ADDENDUM NO. 1

**For: Humble Independent School District
AMS / HMS Additions & Renovations
10203 Birchridge Drive
Humble, TX 77338**

PREPARED BY: PFLUGER ARCHITECTS

ADDENDUM DATE: May 26, 2026

ISSUED FOR CONSTRUCTION
C10.0
DRAINAGE PLAN

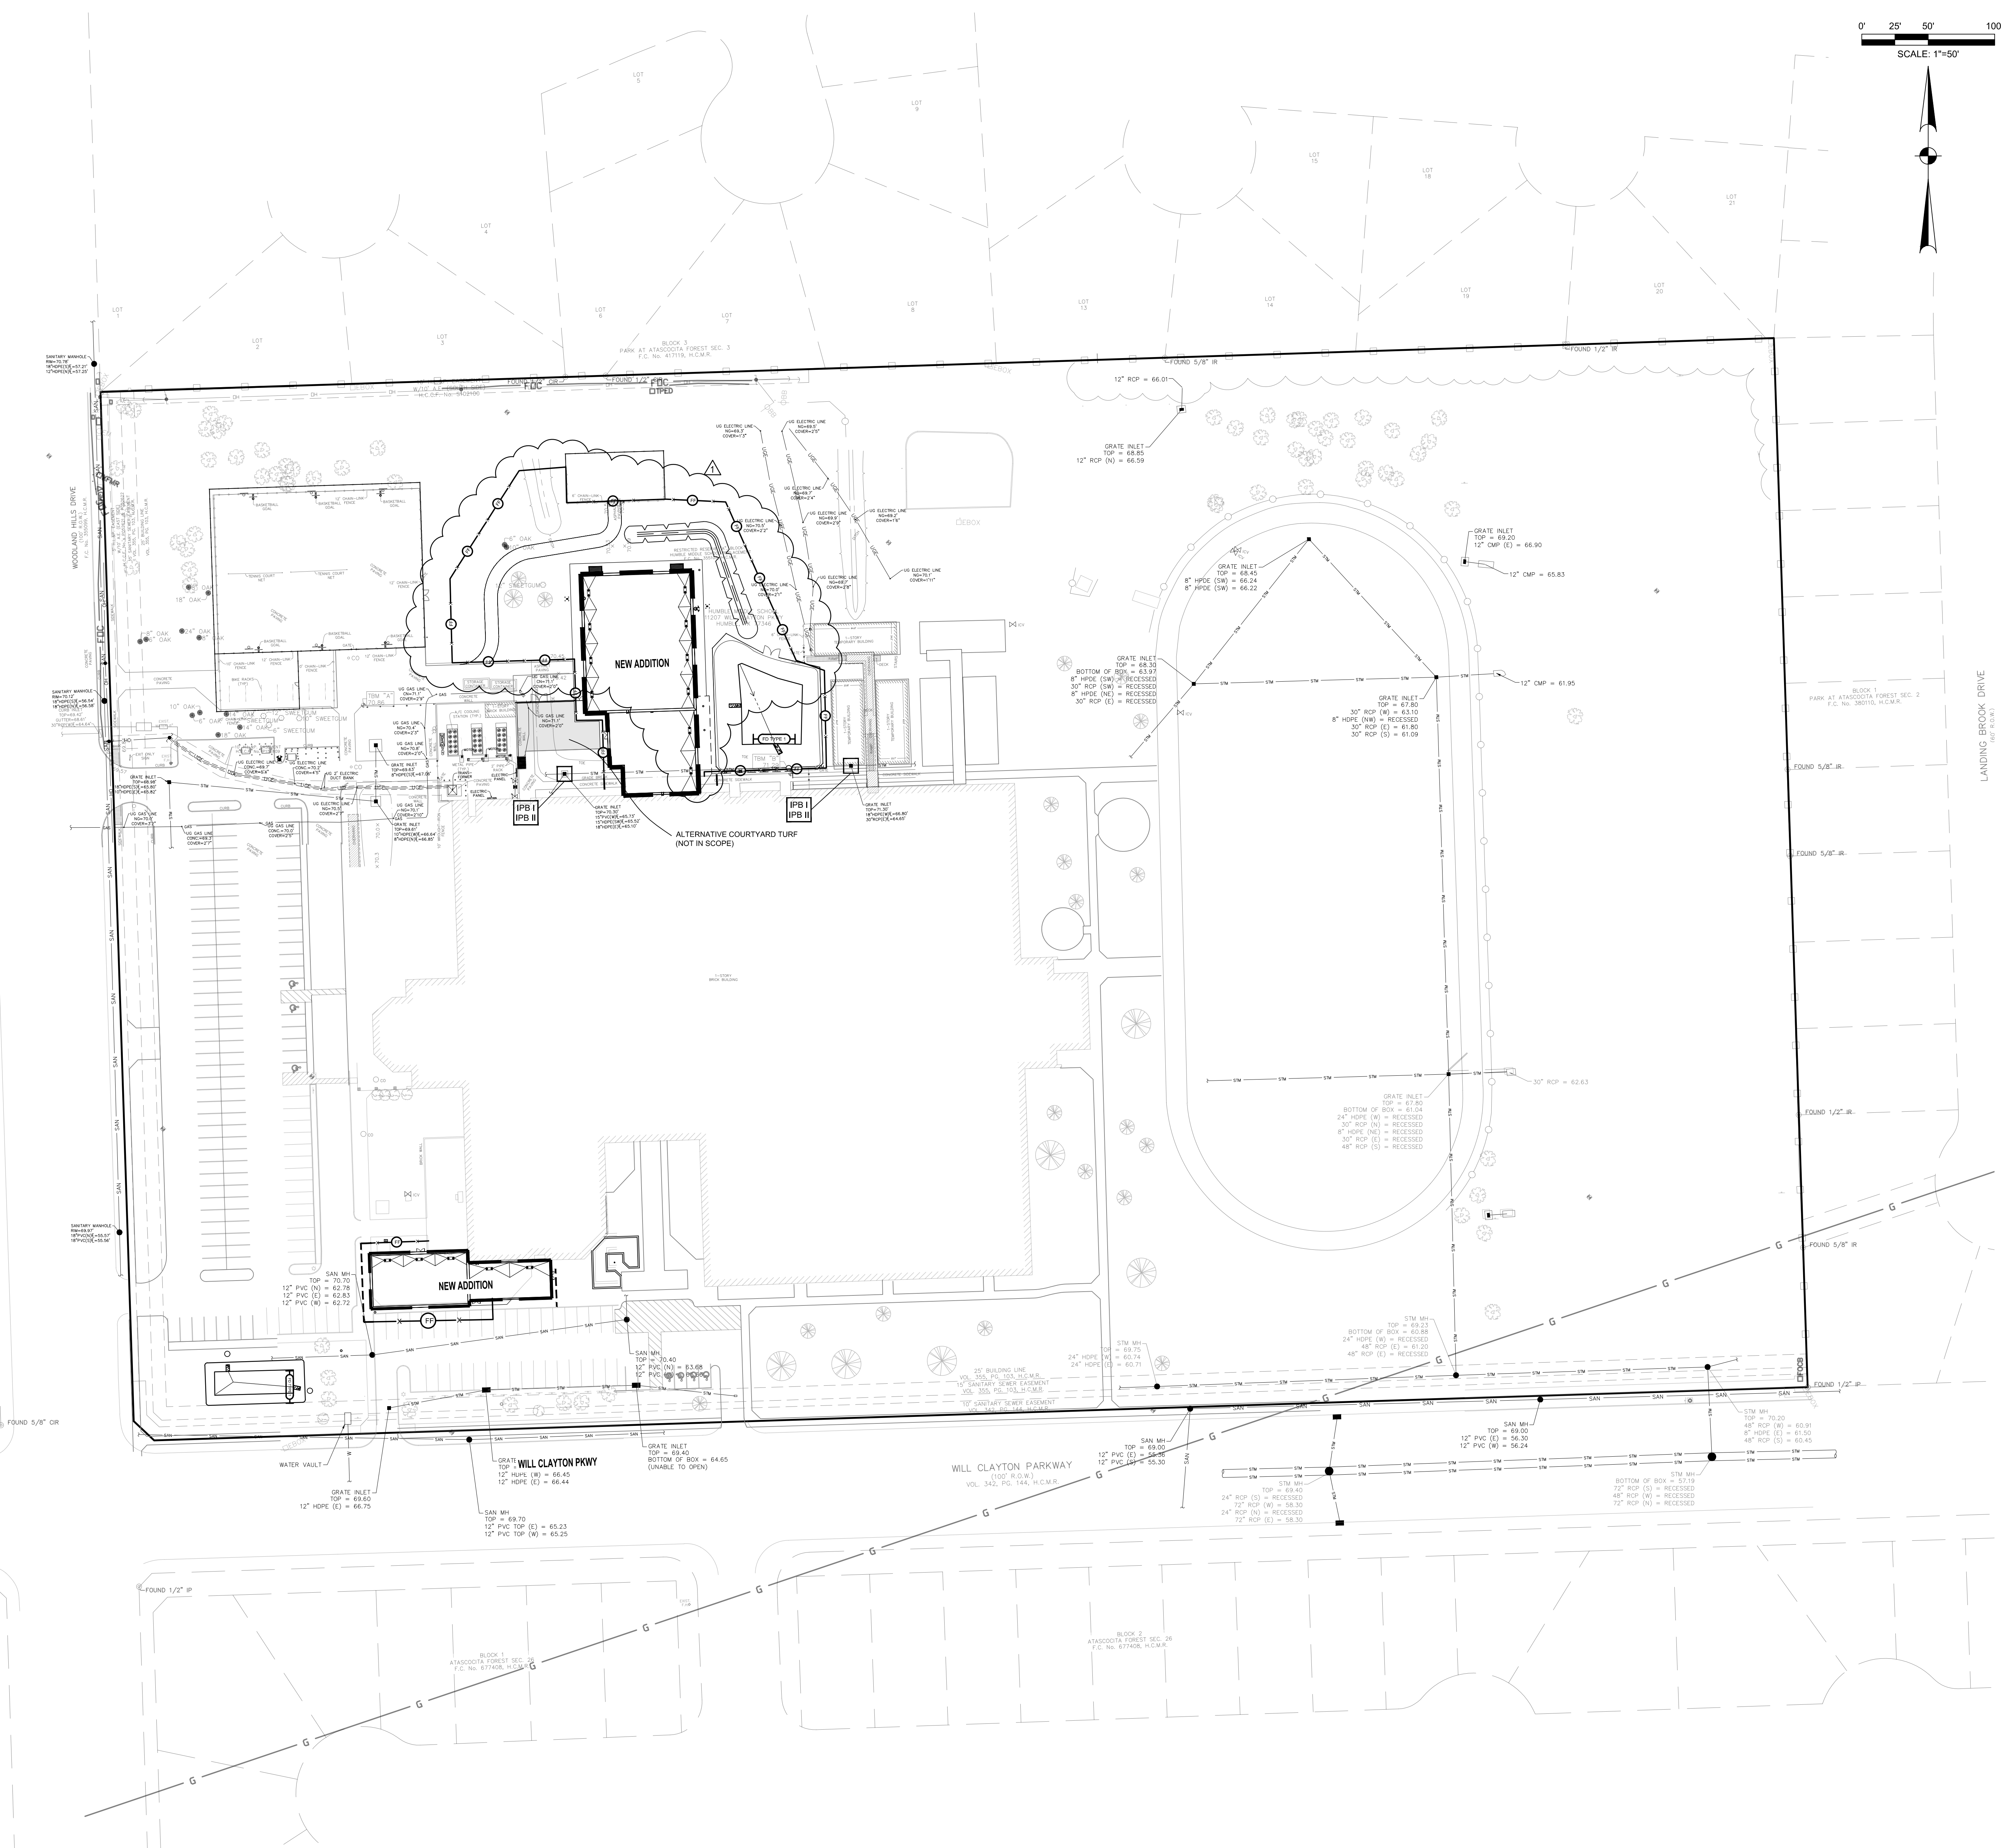
D1-17	C9.00	Revised proposed pond stage storage table.
D1-18	C9.00	Added keynote G2 for contractor to grade for positive drainage near north pond.
D1-19	C10.00	Added drainage flow arrows near new cell tower drive layout.
D1-20	C10.00	Updated impervious cover calculations.
D1-21	C10.00	Updated detention summary calculations.
D1-22	C10.00	Updated restrictor calculations.
D1-23	C11.00	Revised proposed filter fabric fence layout.

ISSUE FOR CONSTRUCTION
1AD01.01
HMS - DEMOLITION SITE PLAN/ROOF PLAN

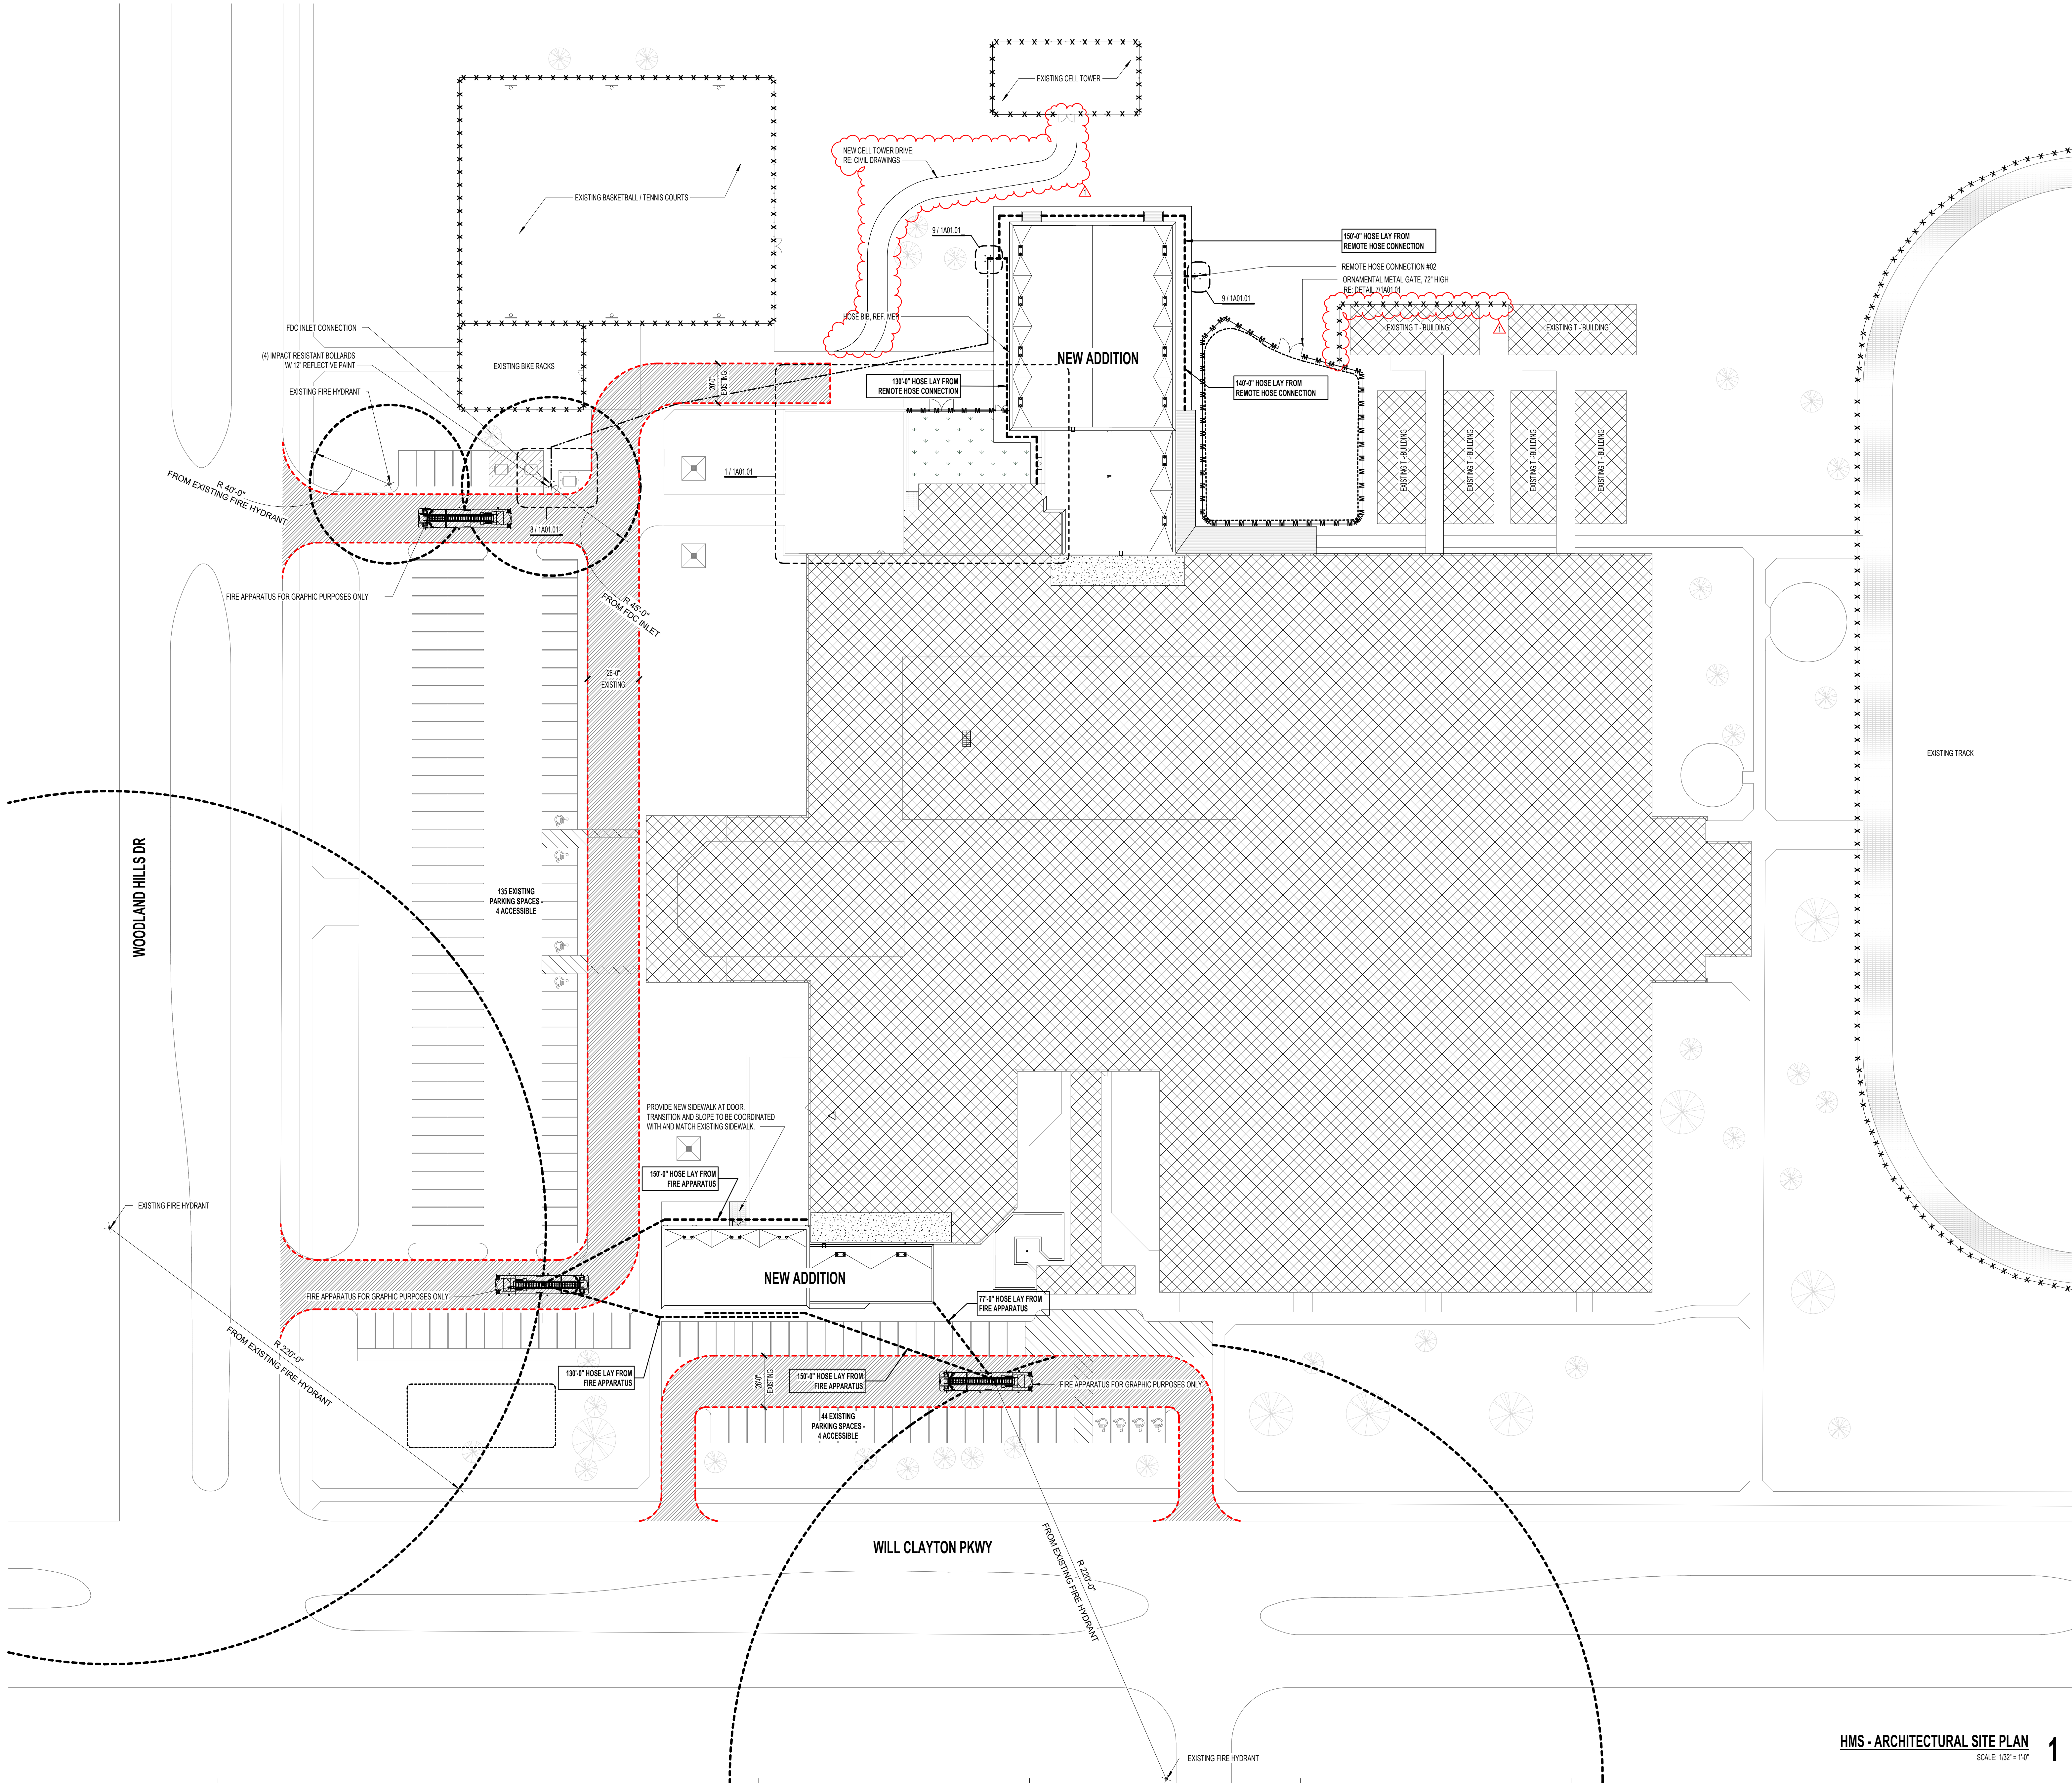
ITEM	SHEET	DESCRIPTION
D1-1	1AD01.01	Extended the area to be demolished at the existing cell tower drive.

D1-2	1AD01.01	Added existing fencing to the drawings and included a keynote indicating where fencing shall be removed at the new detention pond location.
D1-3	1A01.00	Added pavement at the new cell tower drive and included a note to reference Civil drawings.
D1-4	1A01.00	Added existing fencing to the drawings.
